Access Report (DA)

Residential Development
5 Rynan Avenue
Edmondson Park NSW

Client: KMT Pty Ltd

PROJECT
PROPOSED RESIDENTIAL
DEVELOPMENT AT 5 RYMAN AVENUE,
EDMONDSON PARK
DRAWING TITLE
BASEMENT FLOOR PLAN

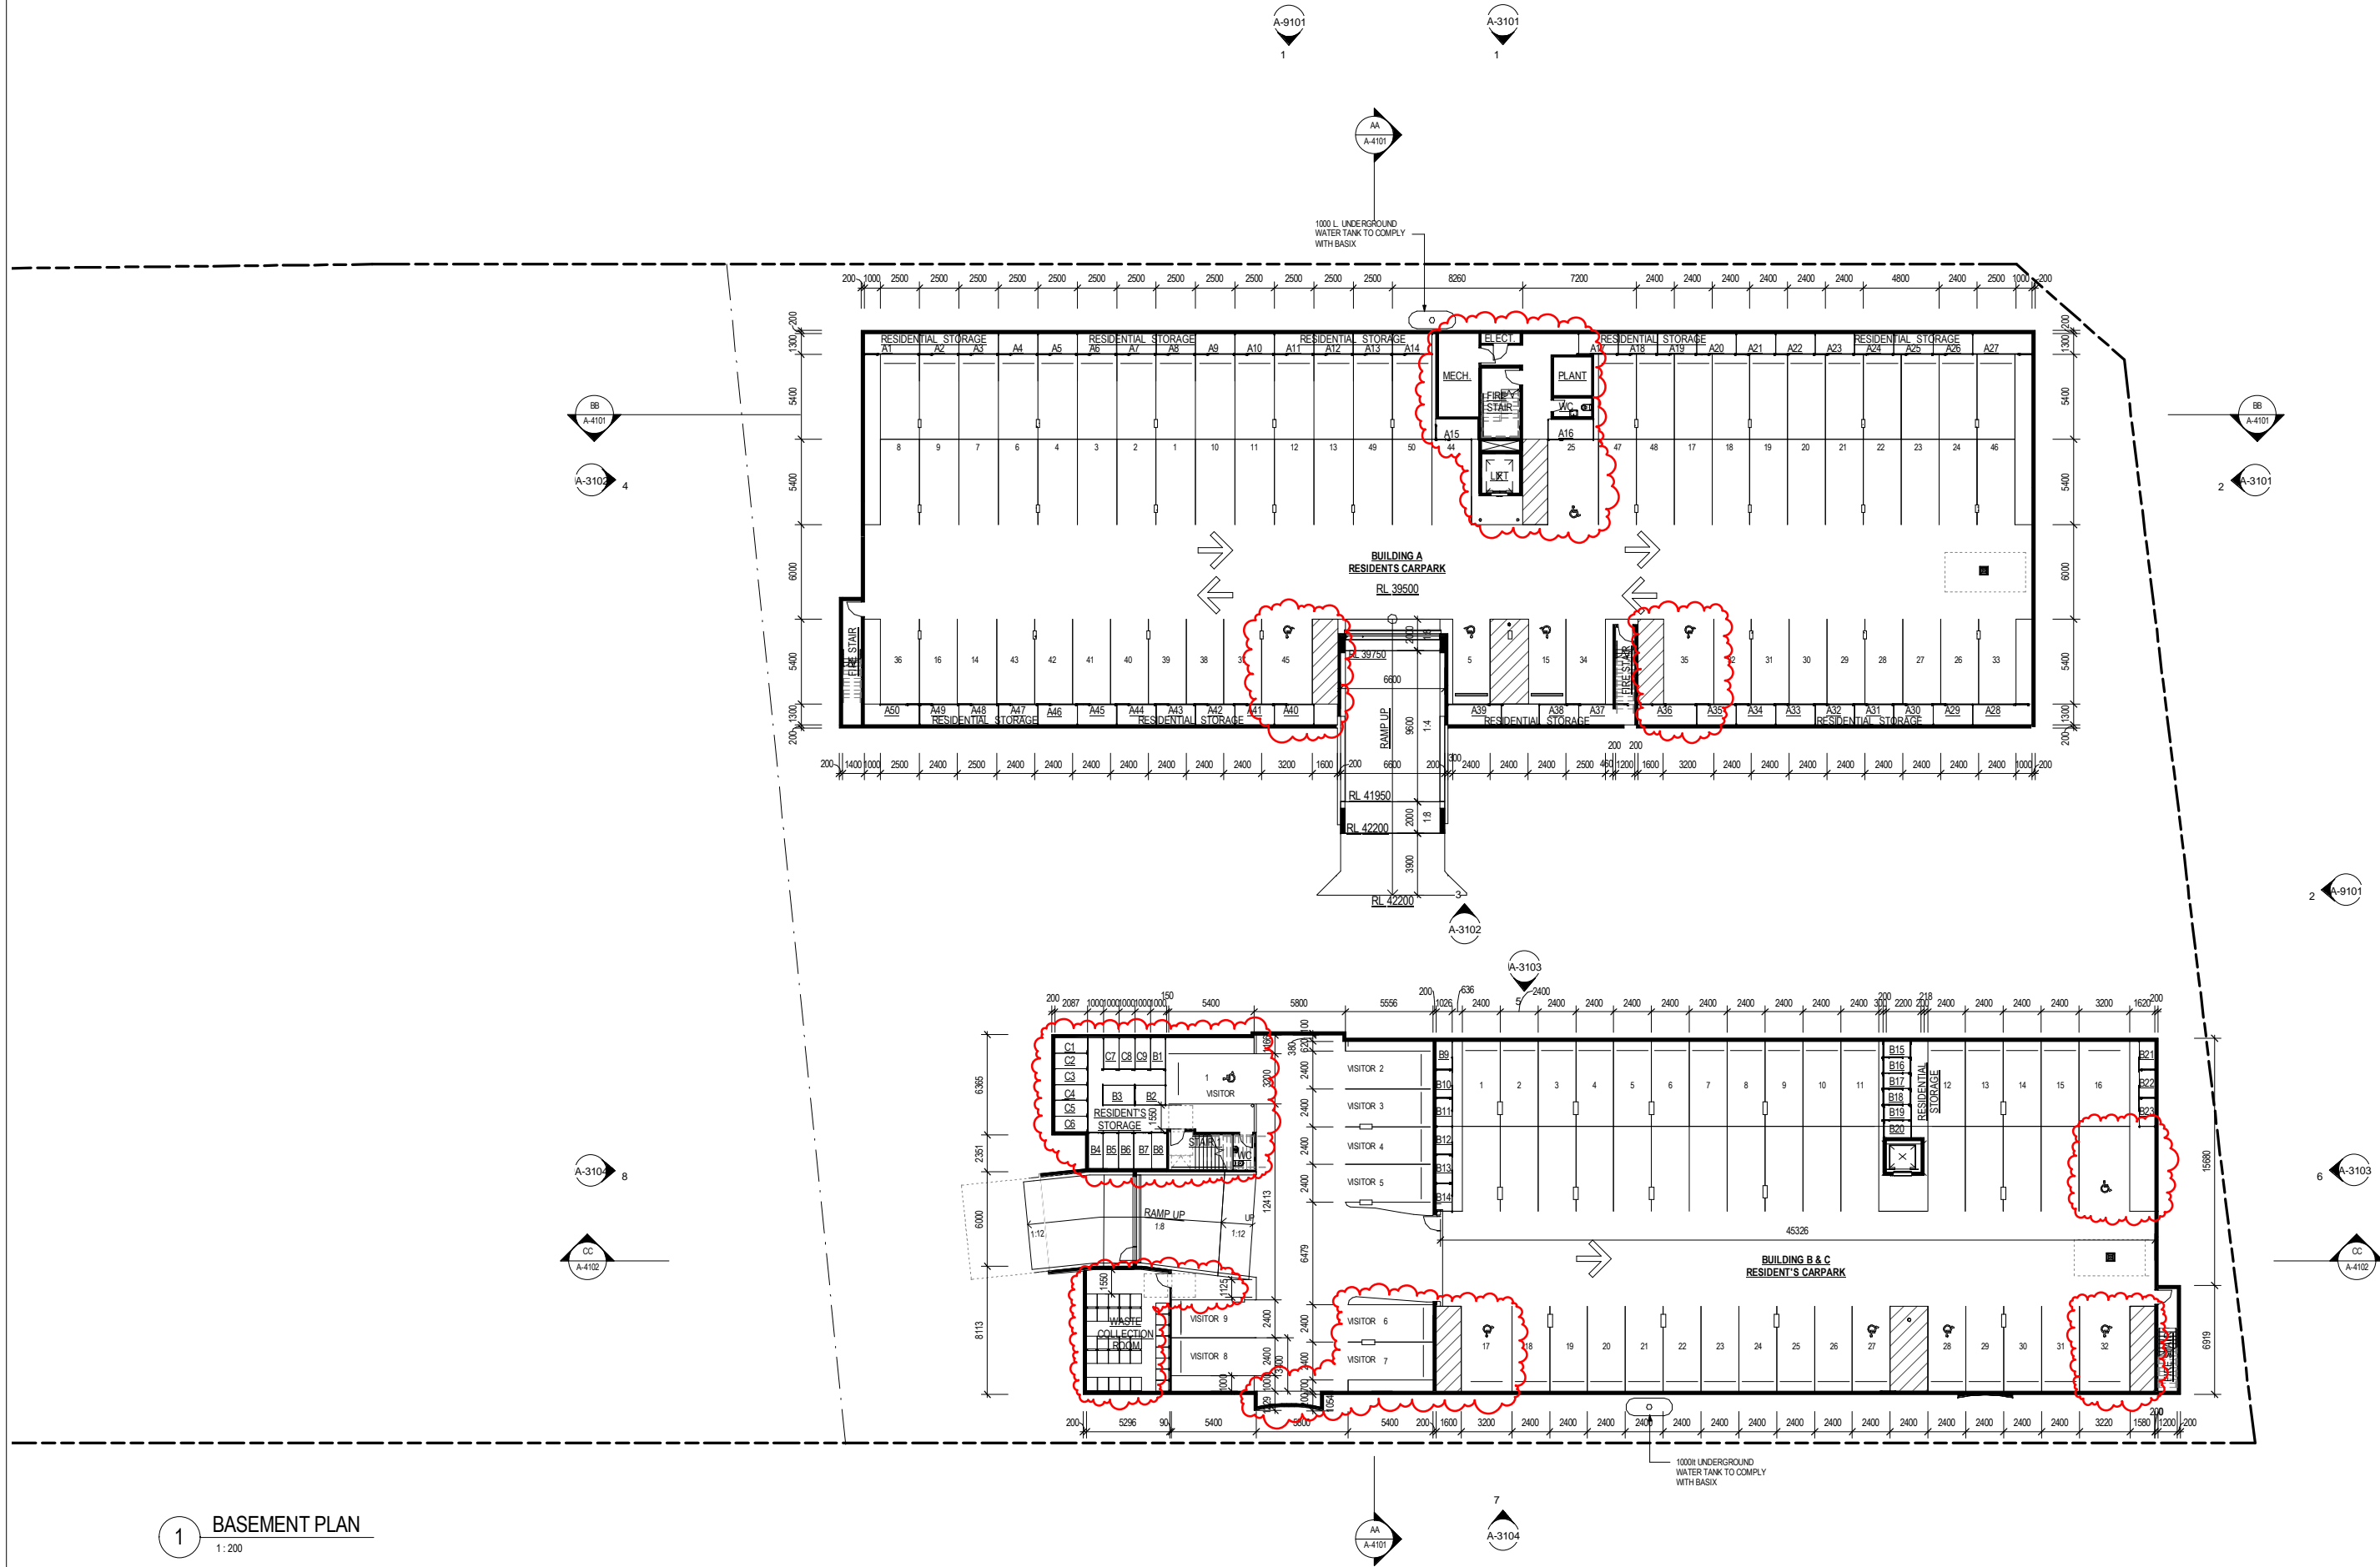
BCA Clause		Status	Comment/Recommendation
			Access is generally provided to and within the basement car parking areas provided within this development.
D3.2	<p>Access to buildings</p> <p>An accessway must be provided to a building required to be accessible:</p> <ul style="list-style-type: none"> (i). From the main points of a pedestrian entry at the allotment boundary; and (ii). From another accessible building connected by a pedestrian link; and (iii). From any required accessible car parking on the allotment. <p>In a building required to be accessible, an accessway must be provided through the principal pedestrian entrance and:</p> <ul style="list-style-type: none"> (i). Through not less than 50% of all other pedestrian entrances, including the principal pedestrian entrance; and (ii). In a building with a total floor area more than 500m², a pedestrian entrance which is not accessible must not be located more than 50m from an accessible pedestrian entrance. <p>Where a pedestrian entrance required to be accessible has multiple doorways:</p> <ul style="list-style-type: none"> (i). If the pedestrian entrance consists of not more than 3 doorways – not less than 1 of those doorways must be accessible; and (ii). If an accessible entrance consists of more than 3 doorways – not less than 50% of those doorways must be accessible. <p>An accessible pedestrian entrance with multiple doorways is considered to be one pedestrian entrance where:</p> <ul style="list-style-type: none"> (i). All doorways serve the same part or parts of the building; and (ii). The distance between each doorway is not more than the width of the widest doorway at that pedestrian entrance. <p>Where a doorway on an accessway has multiple leaves (except an automated opening door) one of the leaves must have a clear</p>	Capable of complying at CC stage	<p>Accessways</p> <p>Accessways are required from the main entry point at the allotment boundary, from any other accessible building and any accessible car parking space to the main entrance door of each building.</p> <p>Accessways from the allotment boundary, adjoining accessible buildings, basement and external car parking areas are generally proposed to the main entry point to each building as required.</p> <p>Access to Buildings</p> <p>Each building has provision for direct street pedestrian access from the new internal road and car parking areas provided within this development.</p> <p>The main entrance door to each building must have a minimum 850mm clear wide opening and door circulation space (internal and external) complying with AS1428.1-2009.</p> <p>In addition to the main entrance door to each building, 50% of all other entrance doors must be accessible or if located more than 50 metres away from the main entrance door, must be an accessible doorway.</p> <p>Where an entrance door has multiple doorways, at minimum one of the doorways must be accessible with a 850mm clear wide opening complying with AS1428.1-</p>

D3.5	<p>Accessible car parking</p> <p>Accessible car parking spaces:</p> <ul style="list-style-type: none"> (i). Subject to (ii), must be provided in accordance with Table D3.5 in: <ul style="list-style-type: none"> – A Class 7a building required to be accessible; and – A car parking area on the same allotment as a building required to be accessible. (ii). Need not be provided in a Class 7a 	Capable of complying at CC stage	<p>The accessible car parking provided within this development must comply with AS2890.6-2009.</p> <p>Class 2</p> <p>A total of five (5) residential accessible car parking spaces will be provided within the Building A basement car park.</p>

BCA Clause		Status	Comment/Recommendation
	<p>building or car parking area where a parking service is provided and direct access to any of the car parking spaces is not available to the public.</p> <p>(iii). Subject to (iv), must comply with AS2890.6.</p> <p>(iv). Need not be designated where there is a total of not more than 5 car parking spaces, so as to restrict the use of the car parking space only for people with a disability.</p> <p>Class 2</p> <p><i>The BCA has not requirement for accessible car parking within a Class 2 building.</i></p> <p><i>One accessible car parking space per accessible unit will be provided in accordance with AS4299-1995 or as per Liverpool City Council's Development Control Plan.</i></p> <p>Class 7a</p> <p><i>1 space for every 100 car parking spaces.</i></p>		<p>A total of five (5) residential accessible car parking spaces will be provided within the Building B & C basement car park.</p> <p>The accessible car parking space must be a minimum 2400mm wide x 5400mm long and must have provision for a 2400mm x 5400mm shared zone.</p> <p>Where accessible car parking widths are not achievable, an alternative solution will be required at CC stage by a suitably qualified Access Consultant.</p> <p>Class 7a</p> <p>A total of two (2) at grade accessible visitor car parking spaces will be provided for Building A and one (1) accessible visitor car parking space will be provided within the basement car park for Building B & C.</p> <p>The accessible visitor car parking space must be a minimum 2400mm wide x 5400mm long and must have provision for a 2400mm x 5400mm shared zone.</p> <p>The accessible car parking space must have a minimum 2500mm overhead clearance (pipes, beams and cable trays should not intrude into this overhead clearance).</p> <p>The entrance door and the vehicle path of travel must have a minimum 2200mm overhead clearance.</p> <p>Appropriate identification (international symbol of access) and line marking must be provided to the accessible car parking spaces and shared zones.</p> <p>The shared zone must have a bollard to prevent unauthorised parking by residents or</p>

BCA Clause		Status	Comment/Recommendation
			<p>visitors.</p> <p>The cross-fall within the basement car park and the external car park must not exceed 1 in 40 in any direction (for drainage purposes).</p>
D3.6	<p>Signage</p> <p>In a building required to be accessible – braille and tactile signage complying with Specification D3.6 must:</p> <ul style="list-style-type: none"> (i). Incorporate the international symbol of access or deafness, as appropriate, in accordance with AS1428.1 and identify each: <ul style="list-style-type: none"> - Sanitary facility, except a sanitary facility within a sole occupancy unit in a Class 1b or Class 3 building; and - Space with a hearing augmentation system. (ii). Identify each door required by E4.5 to be provided with an exit sign and state: <ul style="list-style-type: none"> - “Exit”; and - “Level” followed by the floor level number. (iii). Signage including the international symbol for deafness in accordance with AS1428.1 must be provided within a room containing a hearing augmentation system identifying: <ul style="list-style-type: none"> - The type of system; and - The area covered within the room; and - If receivers are being used and where the receivers can be obtained. (iv). Signage in accordance with AS1428.1 must be provided for accessible unisex sanitary facilities to identify if the facility is suitable for left or right handed use. (v). Signage to identify an ambulant accessible sanitary facility in accordance with AS1428.1 must be located on the door of the facility. (vi). Where a pedestrian entrance is not accessible, directional signage 	<p>Capable of complying at CC stage</p>	<p>All signs relating to access must comply with Specification D3.6 and AS1428.1-2009.</p> <p>Signs must be positioned latch side 1200mm-1600mm from the floor surface.</p> <p>Signage must be easy to read (large print if possible), non reflective and include legible braille and tactile.</p> <p>Fire Egress</p> <p>Signage must be provided to all emergency evacuation doors stating “Exit” and “Level” followed by the floor number.</p> <p>Directional signage must be provided directing a person with a disability to the emergency exit on each floor.</p> <p>Non-Accessible Entrance</p> <p>Where a non-accessible entrance is provided, a sign must be provided within the international symbol of access and an arrow directing a person with a disability to the nearest accessible entrance.</p> <p>Signage details to be provided during CC stage for review.</p>

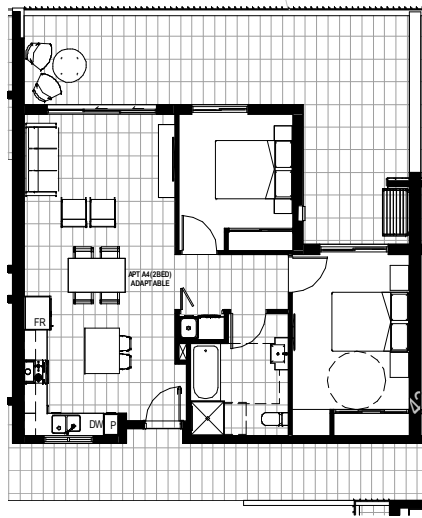
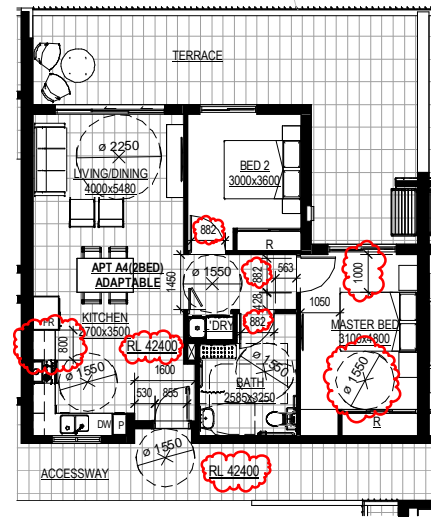
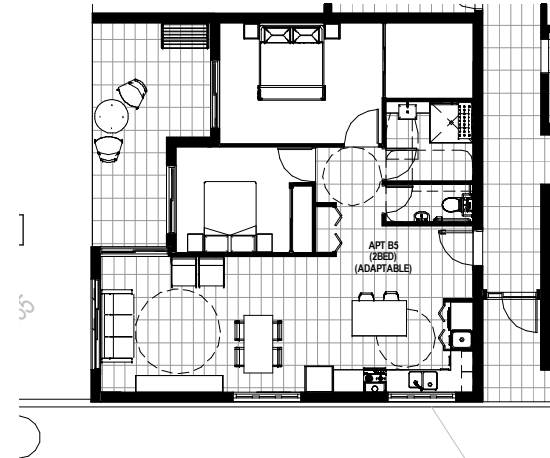
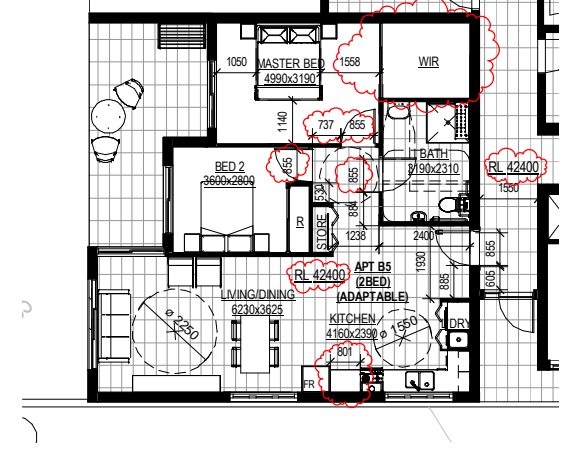
Item		Status	Comment/Recommendation
1	Pre and Post Adaptation of Adaptable Dwellings		
	To obtain certification as an adaptable dwelling 'as built' drawings showing the dwelling in pre-adaptation and post-adaptation stages must be provided.	Capable of complying at CC stage	The pre and post adaptation plans must show compliance with AS4299-1995 Class C Schedule of Adaptable Features.
2	Site		
	A continuous accessible path of travel from the street, letterboxes, car parking, and common areas is provided to the building entry.	Capable of complying at CC stage	A continuous accessible path of travel (without steps or stairs) must be provided from the pedestrian allotment entrance, letterbox area, car parking and any common areas within this development. The continuous accessible path of travel must be traversable by a wheelchair

Accessible entry to be level (maximum 1 in 40 slope).	Capable of complying at CC stage	The entry to the adaptable unit must be level without any slopes.
	Threshold to be low-level.	Capable of complying at CC stage	The entry to the adaptable sole occupancy must be level without any steps.
	Landing to enable wheelchair maneuverability.	Capable of complying at CC stage	
	Accessible entry door to have 850mm	Capable of	The entrance door to the

Item		Status	Comment/Recommendation
	minimum clearance.	complying at CC stage	adaptable sole occupancy unit must have a 850mm clear opening width when measured from the face of the opened door to the doorstep.
	Door lever handles and hardware to AS1428.1.	Capable of complying at CC stage	The entrance door must have provision for D-lever type handles in accordance with AS1428.1-2009. The door schedule must be provided at CC stage for assessment.
6	Interior: General		
	Internal doors to have 820mm minimum clearance.	Capable of complying at CC stage	The internal doors must have a 820mm (preferred 850mm) clear wide opening when measured from the face of the opened door to the doorstep.
	Internal corridors must be 1000mm wide.	Capable of complying at CC stage	The internal corridors must have a 1000mm clear width except where turning space or door circulation space is required complying with AS1428.1-2009.

Item		Status	Comment/Recommendation
	TV antenna outlet adjacent to GPO's	Design information required at CC stage	
	Lighting that can achieve a minimum 300 lux level.	Design information required at CC stage	
8	Kitchen		
	Minimum width 2700mm (1550mm clear between benches)	Capable of complying at CC stage	A minimum 1550mm clear width must be provided between adjacent kitchen benches or islands.
	Provision for circulation at doors to comply with AS1428.1.	Not applicable	
	Provision for benches planned to include at least one work surface of 800mm length, adjustable in height from 750 to 850mm or replaceable.	Design information required at CC stage	The kitchen must have provision for a 800mm wide bench with adjustable legs and separate from other benches.
	Refrigerator adjacent to work surface.	Design information required at CC stage	
	Kitchen sink adjustable to heights from 750mm to 850mm or replaceable.	Design information required at CC stage

Item		Status	Comment/Recommendation
		CC stage	
	Cooktop to include isolation switch.	Design information required at CC stage	
	Work surface adjacent to cooktop minimum 800mm length and at same height.	Design information required at CC stage	
	Oven located to an adjustable height or replaceable work surface.	Design information required at CC stage	
	GPOs to comply with AS1428.1. At least one double GPO within 300mm of front of work surface.	Design information required at CC stage	The double GPO provided for the kitchen area must be at the same height as the bench.
	GPO to refrigerator to be easily reachable when the refrigerator is in its operation position.	Design information required at CC stage	
	Floor within kitchen area to be slip resistant	Design information required at CC stage	Flooring must have a slip resistant rating.
9	Main Bedroom		
	At least one bedroom of area to accommodate a queen size bed and wardrobe and circulation space requirements of AS1428.2.	Capable of complying at CC stage	Provision for a queen size bed (1530mm wide x 2030mm length) with 1000mm clear width on all sides of the bed and 1550mm clear width in front of a wardrobe.

Item		Status	Comment/Recommendation
	telephone outlet).	required at CC stage	
	2 way switches, one located above bed 1000mm high above floor and another at next to the door.	Design information required at CC stage	
	Lighting that can achieve a minimum 300 lux level.	Design information required at CC stage	
10	Bathroom & Toilet		
	Provision for the bathroom area to be converted to an accessible sanitary facility in accordance with AS1428.1.	Capable of complying at CC stage	The adaptable dwelling must have a bathroom and toilet that can be converted into an accessible sanitary facility complying with AS1428.1-2009. Where capped services are required, this must be indicated on the pre and post adaptable plans.
	Slip resistant floor surface.	Design information required at CC stage	Flooring must have a slip resistant rating.
	No hobs within shower recess area and a minimum size of 1160mm x 1100mm to comply with AS1428.1.	Design information required at CC stage	For ease of plumbing, plumbing work for the shower inlets and outlets to be installed at correct distance from walls as shown in AS1428.1-2009.

Item		Status	Comment/Recommendation
	held shower rose mounted on a slider grabrail or fixed hook (plumbing and wall strengthening required).	information required at CC stage	
	Provision for grabrail in shower to comply with AS1428.1	Design information required at CC stage	Ensure all walls that require a grabrail at post adaptation are strengthened with 12mm structural plywood if timber stud frame walls used.
	Tap sets to be capstan or lever handles with single outlet.	Design information required at CC stage	
	Provision for washbasin with clearances complying with AS1428.1.	Design information required at CC stage	A washbasin with circulation space complying with AS1428.1-2009 must be provided.
	Double GPO beside mirror.	Design information required at CC stage	
11	Toilet		
	Provision of either a 'visitable toilet' or accessible toilet.	Capable of complying at CC stage	Provision for an accessible toilet.

Provision to comply with AS1428.1.	Capable of complying at CC stage	Provision for an accessible toilet complying with AS1428.1-2009. Where capped services are required, this must be indicated on the pre and post adaptable plans.
	Location of WC pan at correct distance from fixed walls.	Design information required at CC stage	For ease of plumbing, plumbing work for the WC to be installed at correct distance from walls as shown in AS1428.1-2009.
	Provision for a grab rail zone.	Design information required at CC stage	Ensure all walls that require a grabrail at post adaptation are strengthened with 12mm structural plywood if timber stud frame walls are used.
	Slip resistant floor surface.	Design information	Flooring must have a slip resistant rating.
